Subject: MHI's Response to US-APWR DCD RAI No. 416-2912 Rev. 0

Response to Request for Additional Information No. 416-2912
Revision 0

RAI NO.: NO. 416-2912 REVISION 0
SRP SECTION: 06.05.02 – CONTAINMENT SPRAY AS A FISSION PRODUCT CLEANUP SYSTEM
APPLICATION SECTION: 6.5.2
DATE OF RAI ISSUE: 6/29/2009

QUESTION NO.: 06.05.02-6

The outline of the water path regarding with ineffective pools

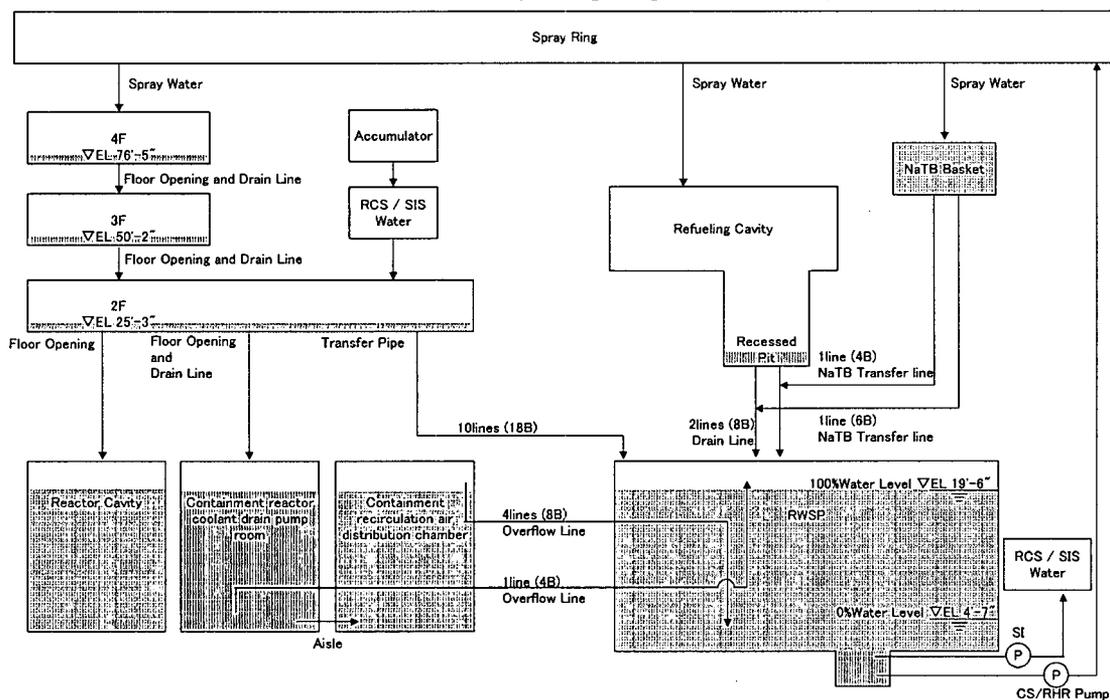
1. Define what is meant by “ineffective pools.” Provide a more detailed description of all containment locations containing water that do not directly participate in recirculation through containment sprays. Note how they accumulate water. If water volumes are indirectly connected to the RWSP, provide detail on how they are connected (pipe size, expected flow patterns, etc.). Note any volumes that are completely unconnected to the RWSP, but that still could accumulate spray water.
2. For all volumes not directly a part of the RWSP-spray recirculation loop (i.e., those noted in question 1), provide an estimate of the (time-varying) pH, NaTB concentration, and fission product concentration.

1. "Ineffective pools" is defined in the report (Reference 1) as a hold-up volume that entraps return water which will not contribute to recovering the RWSP water level. Detailed description of all containment locations containing water that do not directly participate in recirculation through containment sprays are described in the report (Reference 1) and the reply of RAI 331-935 "c. Ineffective pit volume (retained water)" as follows;

- Reactor cavity
- Containment recirculation air distribution chamber
- Containment reactor coolant drain pump room
- Recessed pits in the refueling cavity

The outline of the water path regarding with ineffective pools is shown in following figure. Reactor cavity is completely unconnected to the RWSP and accumulates spray water. Containment recirculation air distribution chamber and containment reactor coolant drain pump room are indirectly connected to RWSP with 4 numbers overflow lines of 8B pipe and one line of 4B overflow pipe respectively. The recessed pits in the refueling cavity are considered as ineffective pools. And the 8B drain lines are connected from the recessed pit to RWSP. In addition, NaTB baskets have ineffective water which is indirectly connected to the RWSP.

NaTB basket is added to the Figure 6.2.1-9 in the DCD.
